SUNDRY NOTICES AND REPORTS ON WELLS

McCroden 7

PLUG AND ABANDONMENT PROCEDURE

CONDITIONS OF APPROVAL

McCroden #7 Proposed P&A

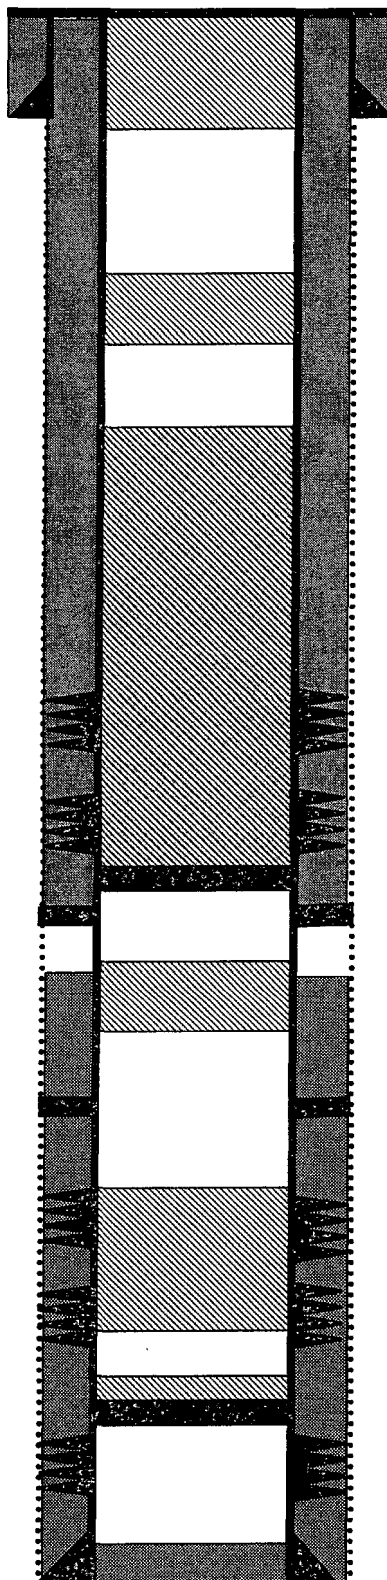
1. Plugging operations authorized are subject to the attached "General Requirements for Permanent Abandonment of Wells on Federal and Indian Lease."
2. Farmington Office is to be notified at least 24 hours before the plugging operations commence (505) 599-8907.
3. The following modifications to your plugging program are to be made:
 - a) Bring the top of the Pictured Cliffs/Fruitland/Kirtland/Ojo Alamo plug to 3382'.
 - b) Place the Nacimiento plug to 2192' – 2092'.

4. **Plug #1 (Mesaverde interval, Pictured Cliffs perforations, top, Fruitland Coal perforations and top, Kirtland and Ojo Alamo tops, 4000' – ^{3382'}~~3525'~~):** Tag existing CIBP at 4000' (1999)'. Mix and pump 65 sxs Type III cement, cover the CIBP at 4000' to further isolate the Mesaverde interval and fill the Pictured Cliffs and Fruitland Coal perforations through the Ojo Alamo top. PUH and WOC. TIH and tag cement. Cement should be at 3525' or higher. If necessary re-spot Plug #1. PUH.

2192' 2092'
5. **Plug #2 (Nacimiento top, ~~1795'~~ – ~~1695'~~):** Mix 11 sxs Type III cement and spot a plug inside the casing to cover the Nacimiento top. PUH to 363'.
